**ADDENDUM #02
TO INVITATION TO BID #01**

**OLD GREENWICH SCHOOL – ADDITIONS AND ALTERATIONS
STATE PROJECT NUMBER 057-0115 EA/RR/CV
285 SOUND BEACH AVE
OLD GREENWICH, CT
APRIL 17, 2025**

2. **SP+A Bulletin #2** - dated April 16, 2025.

SHRUB PLANTING

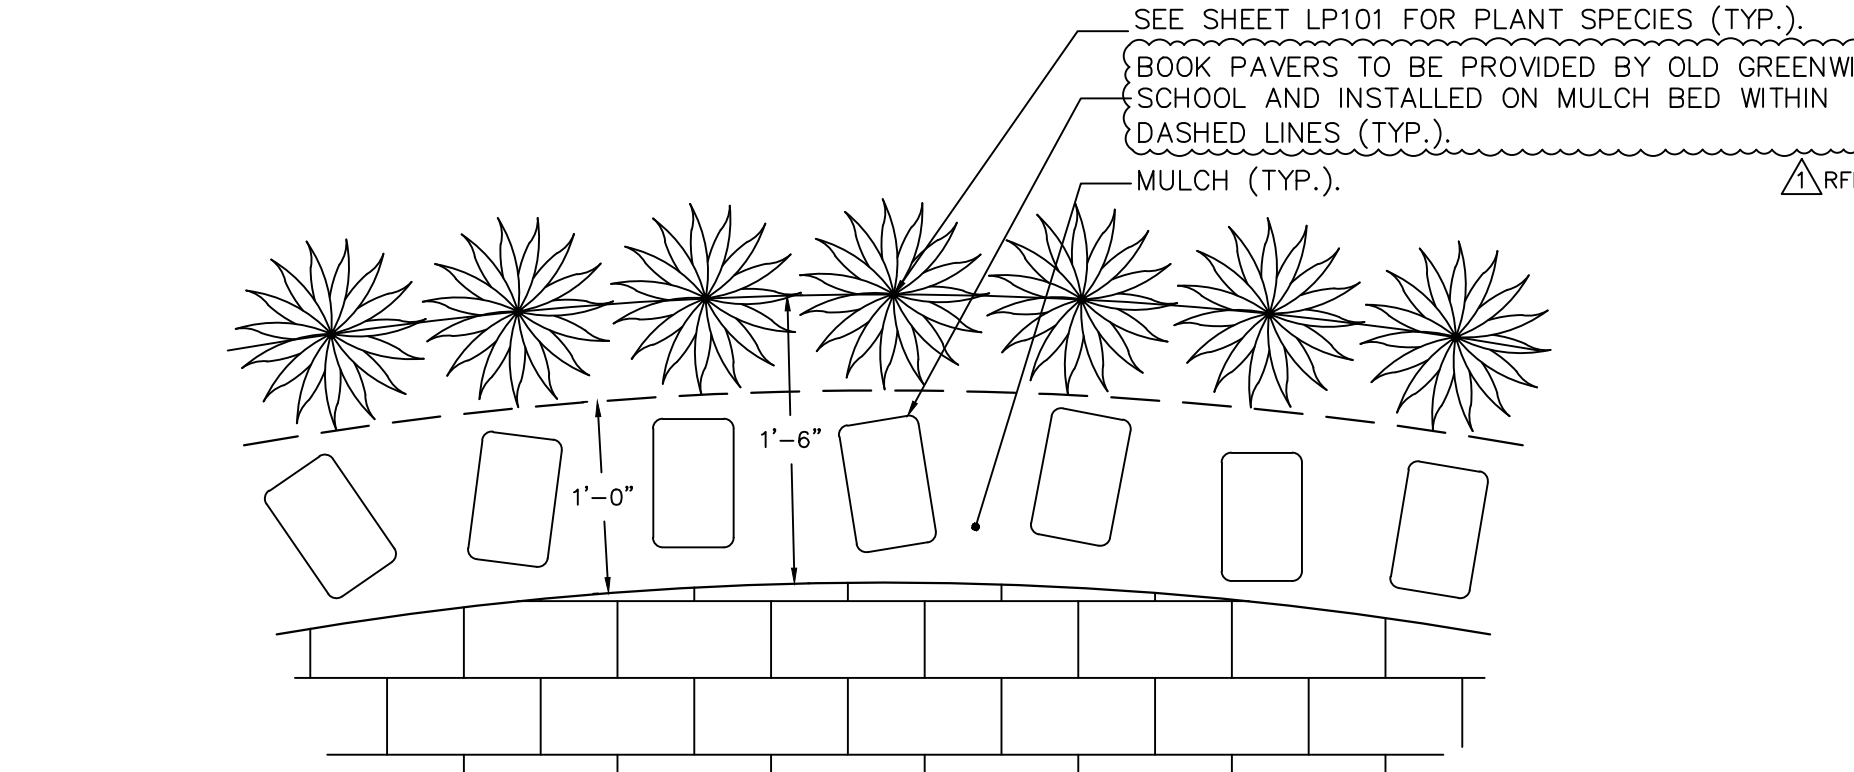
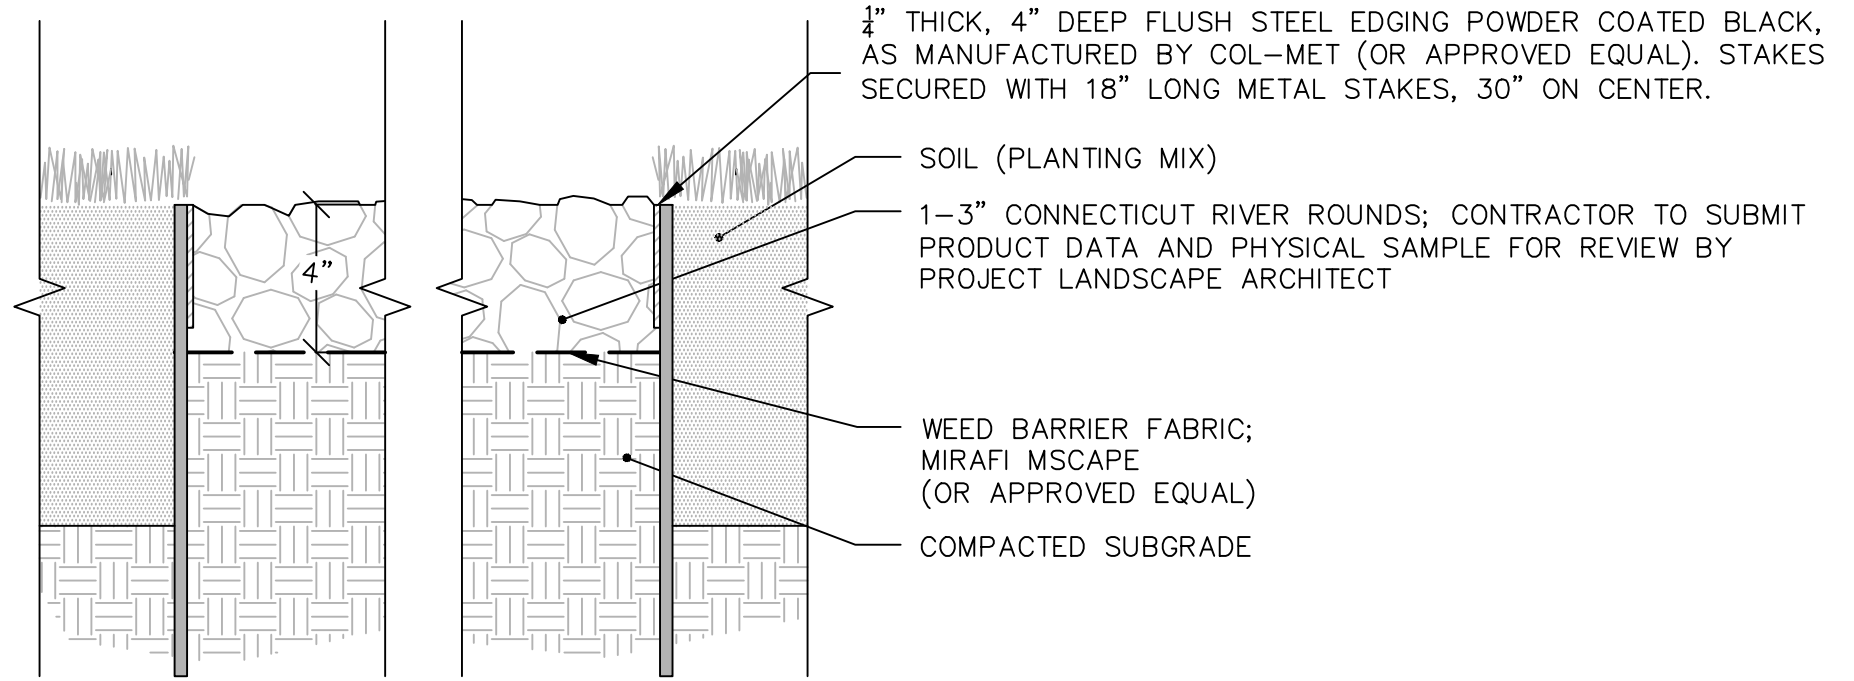
- **RFI #7** **Question:** Detail 5 on LP501 calls for Book Pavers to be installed within Dashed Lines in the Mulch. Are they to sit on mulch or subbase. What is the size of the Book Paver?

Response: Book paver to be set in mulch, no subbase required. Book pavers are provided by Owner. Refer to revised Drawing LP501 in Bulletin #2.
- **RFI #8** **Question:** Please confirm the stone mulch is within the CSK trees. The south planting bed lists the Red Twig Dogwoods as CSK, however, north list tress as CS. Please advise

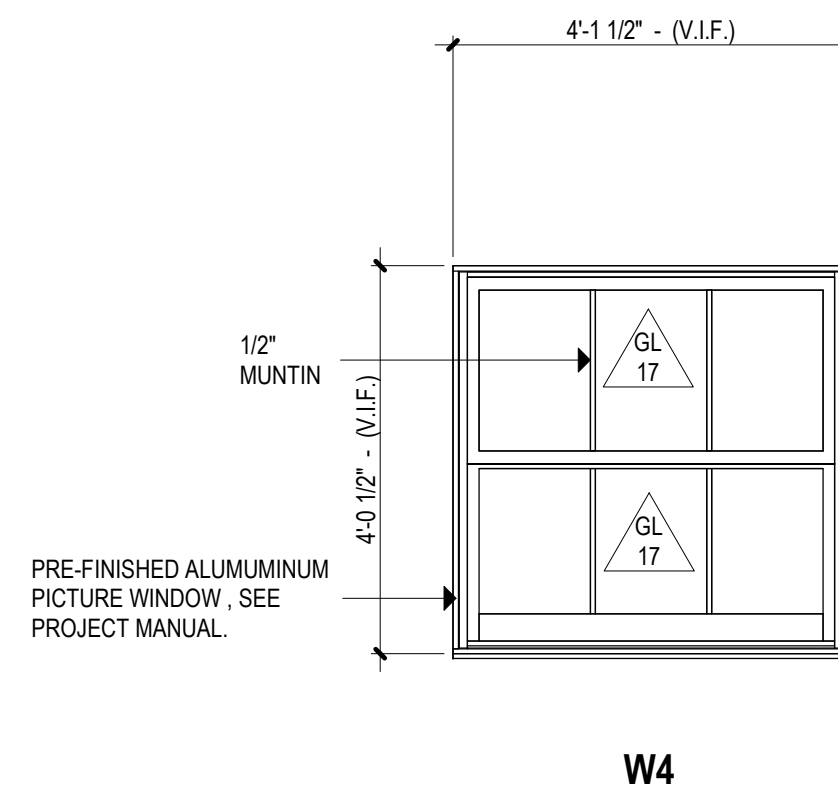
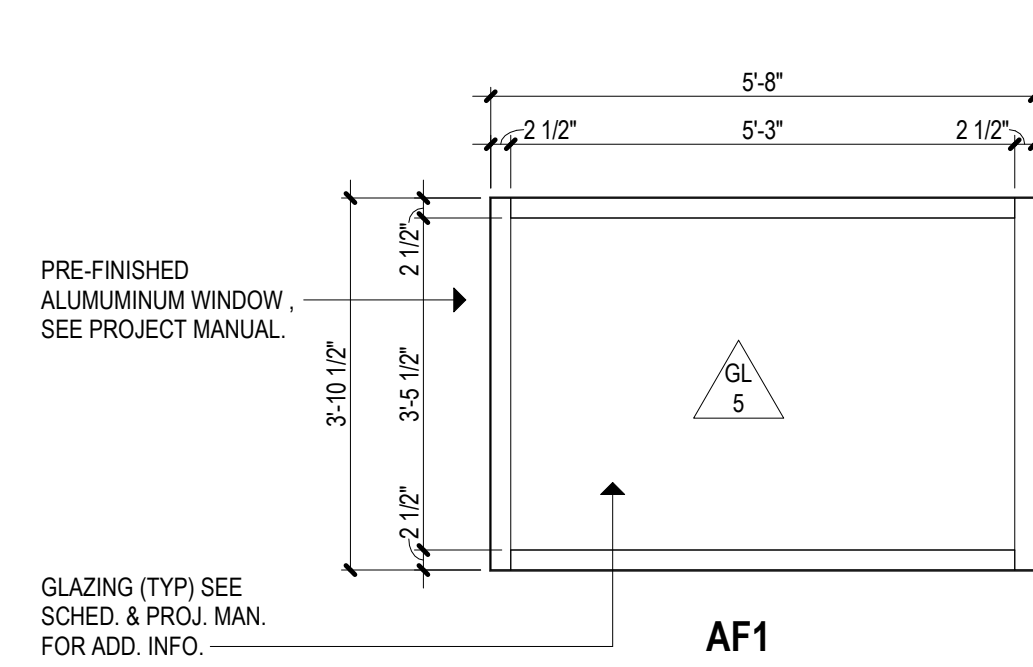
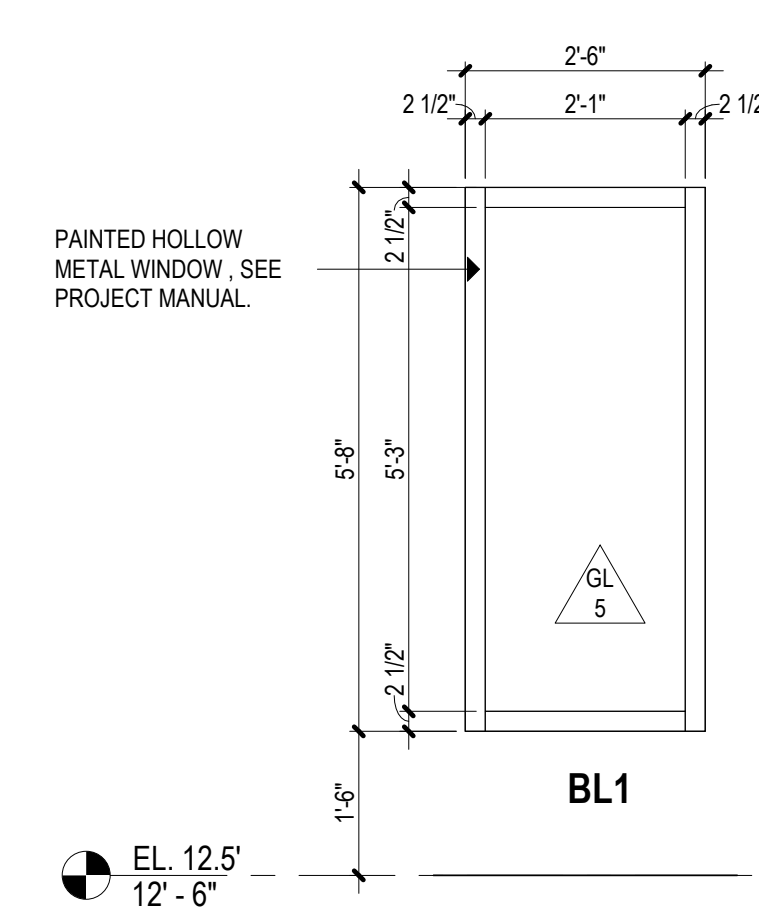
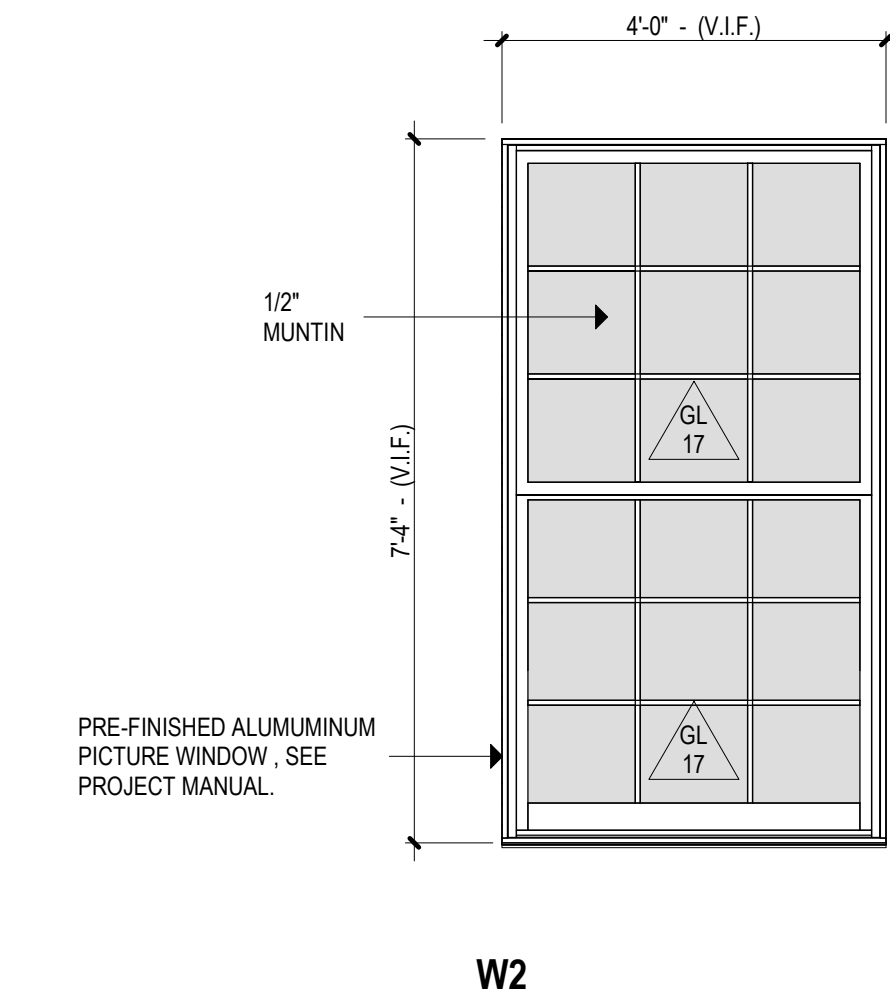
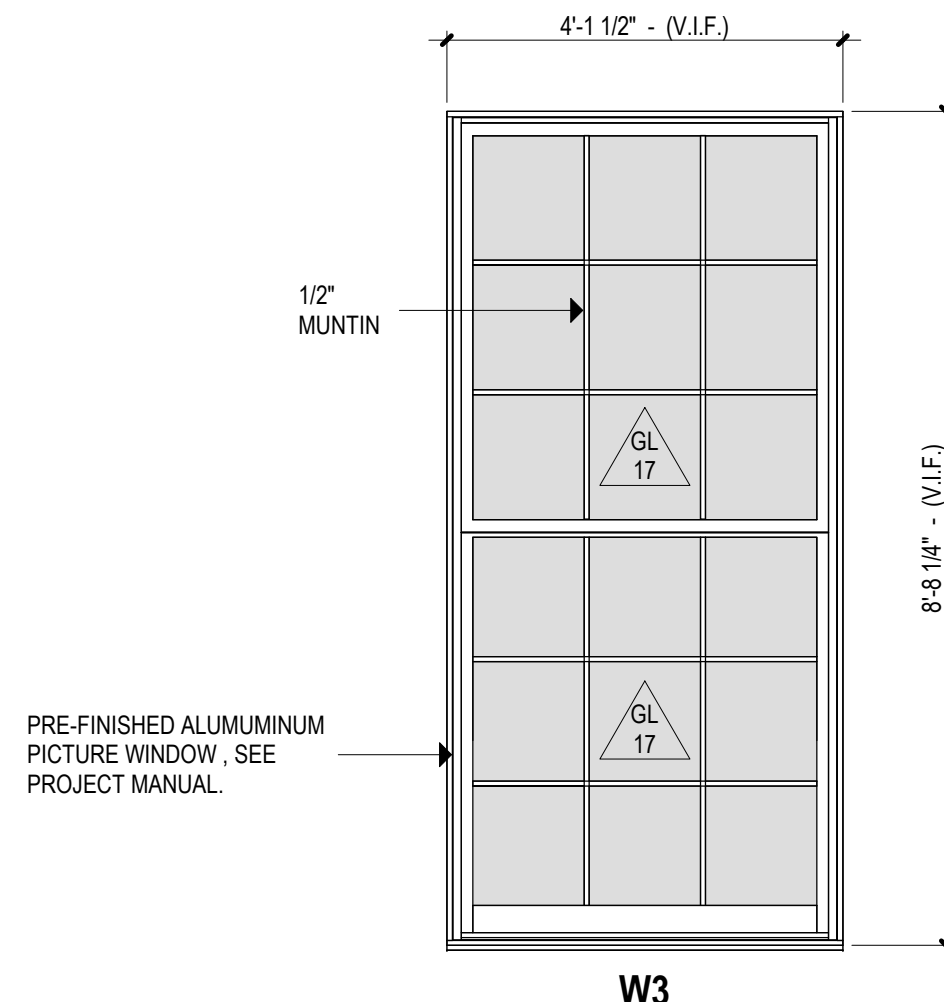
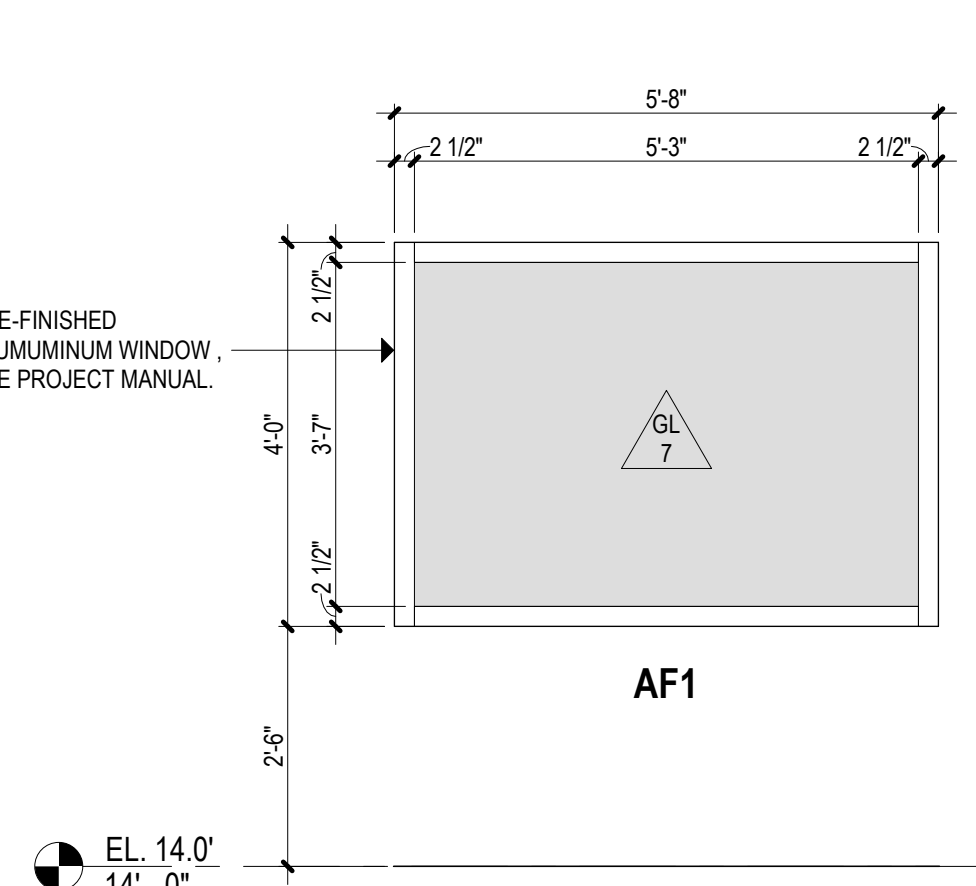
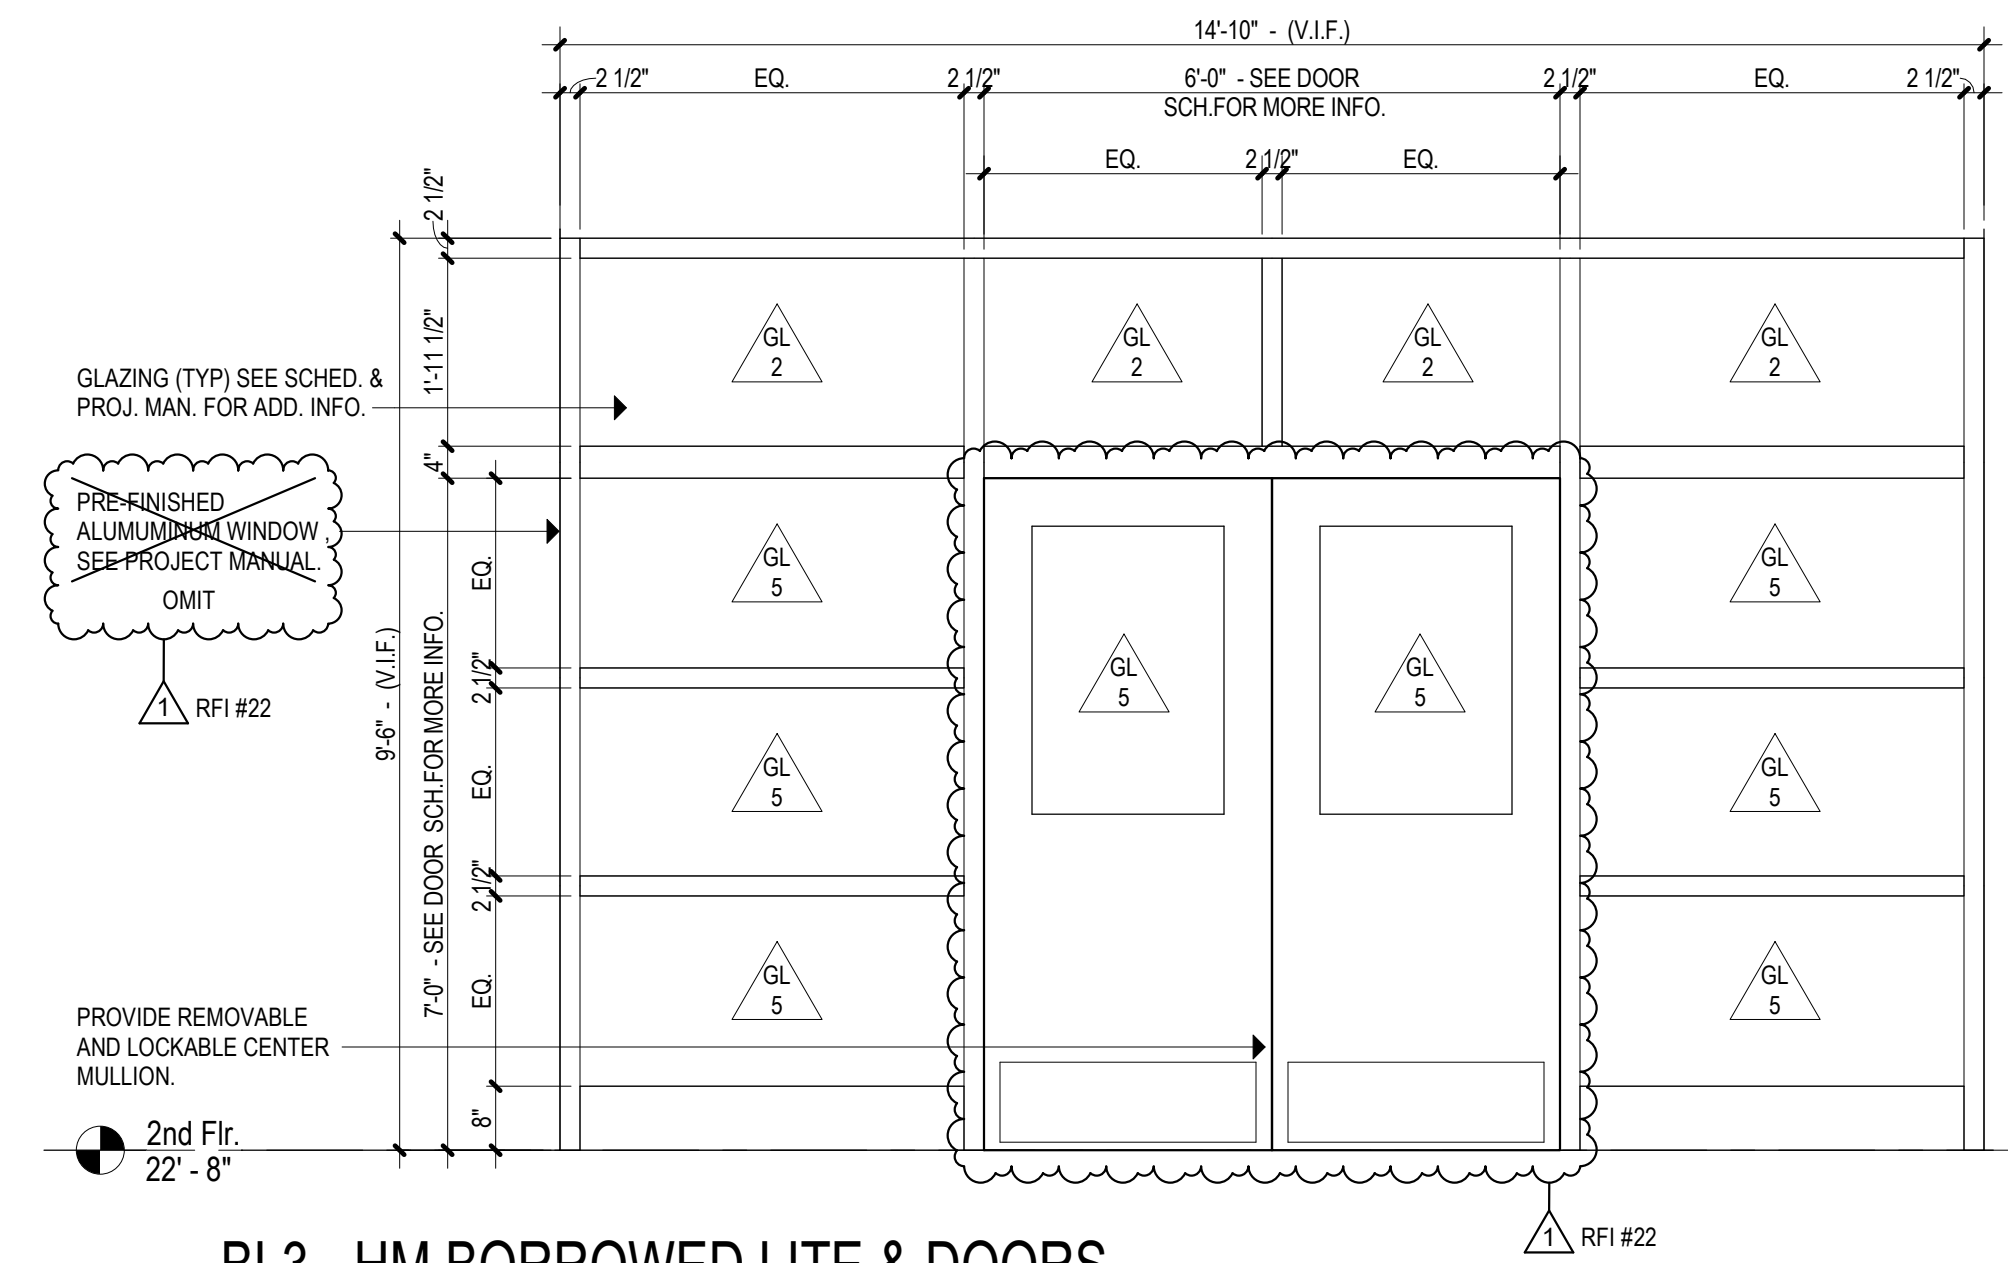
Response: There are no Allowances in BP #1.8.1 - Aluminum Glass and Glazing
- **RFI #22** **Question:** Doors # 2004 and 2012 are shown in the door schedule as AL doors in frame type AF3 + AF4. I do not see these frames shown within the documents. Please review and advise.

Response: Door frames are hollow metal borrowed Lites. Refer to revised Drawings A600 & A911 in Bulletin #2.
